AMENDED BY STAFF 07/22/88
CITY PLANNING COMMISSION

- APPLICATION:**
- A. Negative Declaration
 - B. Reversion to acreage (Withdrawn)
 - C. Tentative Map
 - D. Special Permit to develop 86 petite units.

LOCATION: Sunmeadow Drive & Meadowstone Drive

Planning Director's Special Permit Modification

1 FLOOR PLAN

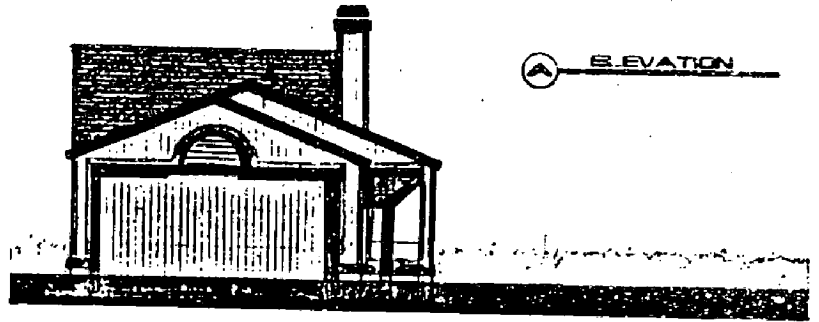
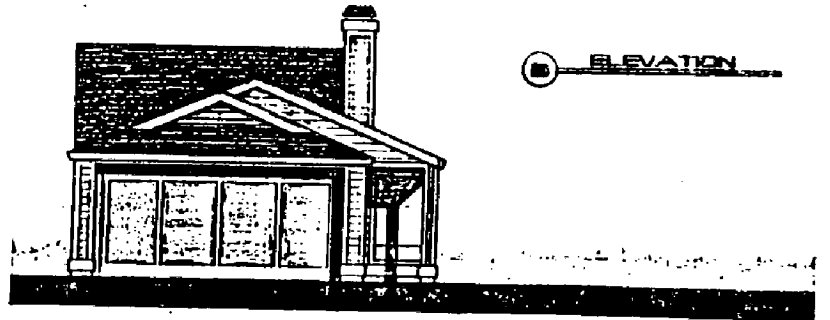
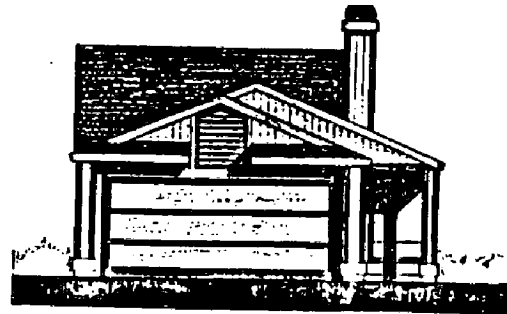
Staff can see little variety in the outside elevations. To prevent a monotonous streetscape, staff recommends additional elevations with different roof treatments, different garage doors and additional building materials such as masonry or brick trim.

In the original staff report, staff recommended that the elevations of the proposed homes be redesigned to show different roof treatments, different garage doors and additional building materials such as masonry or brick trim. The applicant has redrawn his elevations to reflect staff's request and has made some floor plan changes. Staff has no objection to the changes made in the elevations and floor plans.

3. The applicant shall submit additional elevations showing a variety of roof lines and other architectural amenities and building materials such as masonry or brick trim to relieve the monotony of the streetscape. Plans shall be reviewed and approved by Planning staff prior to issuance of building permits.

TENTATIVE SUBDIVISION MAP
 RE SUBDIVISION OF CREEKSIDE PARK
 APR 11, 1988 167 B.M. 13
 CITY OF SACRAMENTO, CALIFORNIA

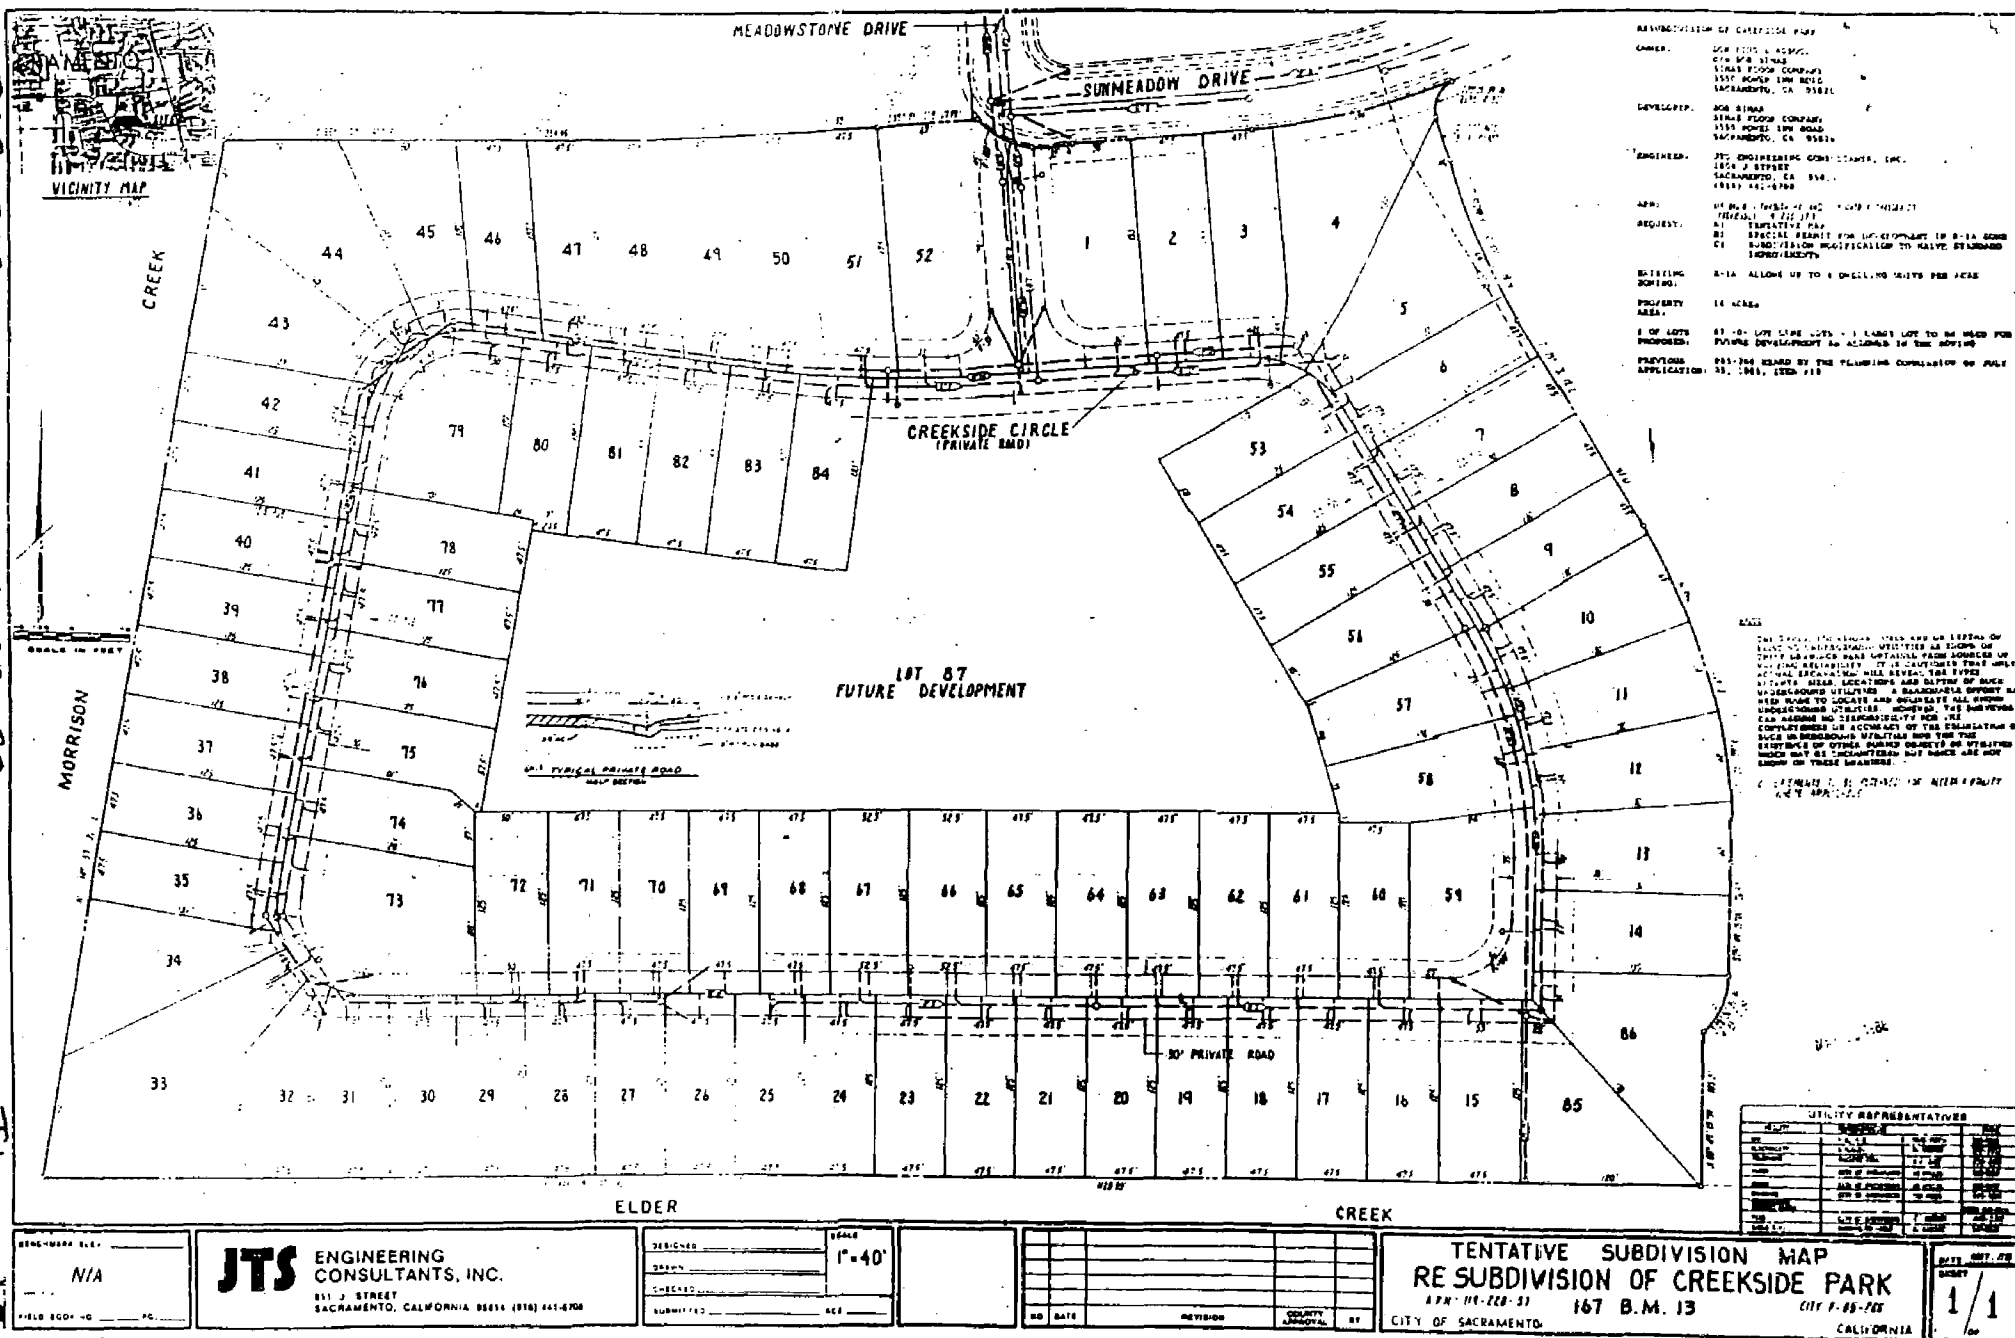
3. Dedicate the private road and 12.5 feet adjacent thereto as a P.U.E. for underground electrical facilities and appurtenances.
4. Dedicate the westerly five feet of Lot 5 and easterly five feet of Lot 4 as a P.U.E. for underground electrical facilities and appurtenances.

5. Dedicate the easterly five feet of Lot 44 and the westerly five feet of Lot 4 as a P.U.E. for underground electrical facilities and appurtenances.
6. Dedicate the north five feet of lot 45 as a P.U.E. for underground electrical facilities and appurtenances.

11. Provide separate water and sewer services to Lot 85.
12. Dedicate easement for future levee widening and levee construction along Morrison Creek and Elder Creek. Width of easements shall be determined by engineering study for floodplain requirements.
